## ***Interactive comment on “Complex networks for streamflow dynamics” by B. Sivakumar and F. M. Woldemeskel***

Response to Referee Comment – S. Scarsoglio (RC C2857):

**Fig. 1.** Degree centrality for four correlation thresholds: (a) 0.70; (b) 0.75; (c) 0.80; and (d) 0.85.

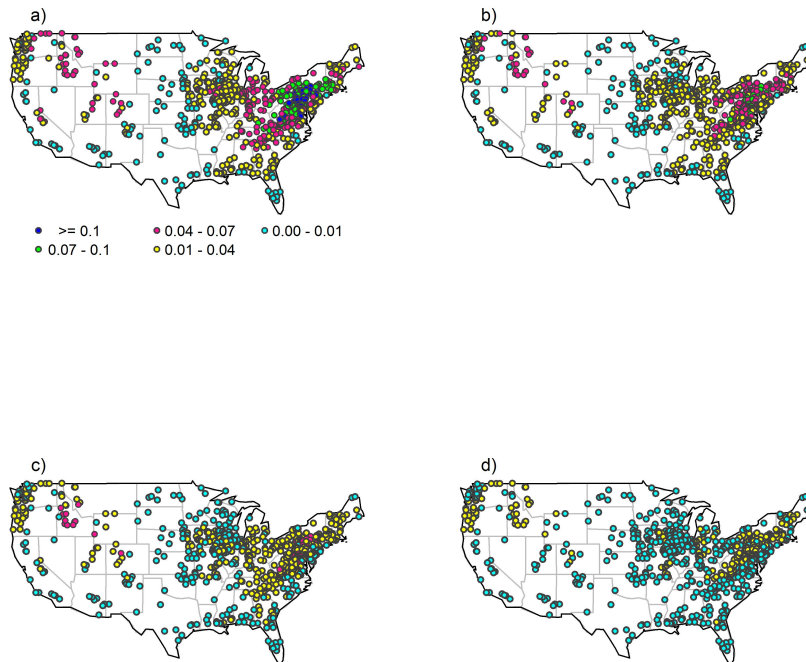
Referee Comment: I understand that the main focus is on the local clustering coefficient and I also understand this work reports preliminary results, but it would be very useful evaluating the streamflow connections also by means of the degree centrality (i.e. (number of first neighbors of node  $i$ )/(total number of possible neighbors)), which is probably the most intuitive network parameter. I think the results can be improved through the analysis of the degree centrality with the same thresholds used for the local clustering. Comparison of the spatial connections highlighted by these two parameters is able to give a more complete network perspective.

Author Response: We thank the reviewer for her suggestion to use degree centrality (in addition to clustering coefficient used earlier) to analyze the streamflow data to put our network analysis in an ever better perspective. We certainly agree with this suggestion. We have carried out the degree centrality analysis for the streamflow data, with the same threshold levels ( $T = 0.70, 0.75, 0.80, \text{ and } 0.85$ ) we used earlier in the clustering coefficient analysis. The results are presented in Figure 1. In the revised manuscript, we will include the description of the degree centrality method and its application to streamflow data. It would be more appropriate to include the degree centrality analysis before the clustering coefficient analysis. Therefore, the description of the degree centrality method will be presented under a new Sub-section 2.2 (with Sub-section 2.3 for clustering coefficient), and the results will be presented under a new Sub-section 4.2 (with Sub-section 4.3 for clustering coefficient).

**Fig. 2.** Density distribution of average distances for three different number of neighbors

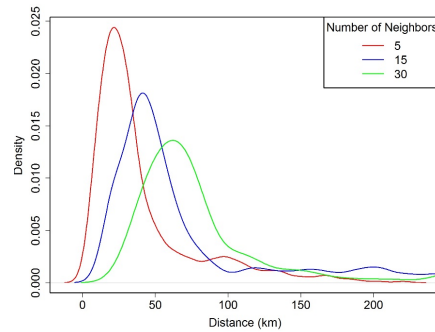
Referee Comment – S. Scarsoglio (RC C2857): In the correlation analysis (4.1), are the neighbors selection based on the geographical distance from the reference node? Is it possible to have some statistical information on the distance (in terms of PDF, if significant, or just in terms of mean and standard deviation) for the three values (5, 15, 30 neighbors)? For each station, compute the average distance from the neighbors, and then evaluate the distance distribution for all the stations for the three values (5, 15, 30).

Author Response: Yes, the neighbors are selected based on the geographical distance from the reference node. We appreciate the reviewer's suggestion to obtain some statistical information on the distance, as such could shed some additional light on

the correlation results. We have now carried out the relevant analysis regarding the average distances for the three number of neighbors we considered, i.e. 5, 15 and 30 neighbors. For these three cases, the mean distances are 41, 73, and 111 km, respectively, and the standard deviations are 37, 63, and 94 km, respectively. We will incorporate these results with relevant interpretation in the revised version. For the benefit of the reviewer, the probability density distributions of the average distances for the the above number of neighbors are presented in Figure 2. We do not, however, see the need to include this figure in the revised version.
